**Project:** Dzero Electrical Support

**Doc. No:** A1050613A

**Subject:** Fusing of Calorimeter Pre-amplifier low voltage wiring

Figure 3

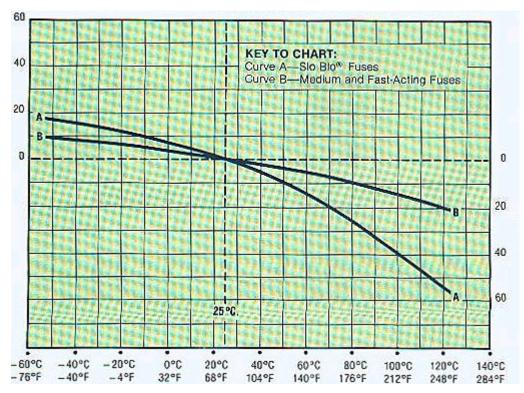
The speculation given is not supported by manufacturer's data sheets. The more likely explanation is a reduction in fuse lifetime from heating, either of the fuseholder or from IR drop in the wiring itself. A typical derating curve for fuses of the fast-blow and slow-blow type is given in Figure 3. Although most people assume that slo-blo fuses are preferred, they do have significantly larger temperature sensitivity.

At this temperature rise a slow-blow fuse may be derated as much as 15%, meaning that the 20A fuse actually acts like a 17A fuse. This is so close to the actual measured currents of the supply that it may explain the consistent fuse failure rate. Use of a fast-blow 20A fuse would result in a derated value of 19 Amps. This simple change may possibly solve the problem of consistent fuse loss without having to re-examine the safety aspects.

- 3. Temperature rise estimates suggest that the use of slo-blo fuses is a mistake and that, if usable, fast-blow fuses will provide greater margin against heat derating.
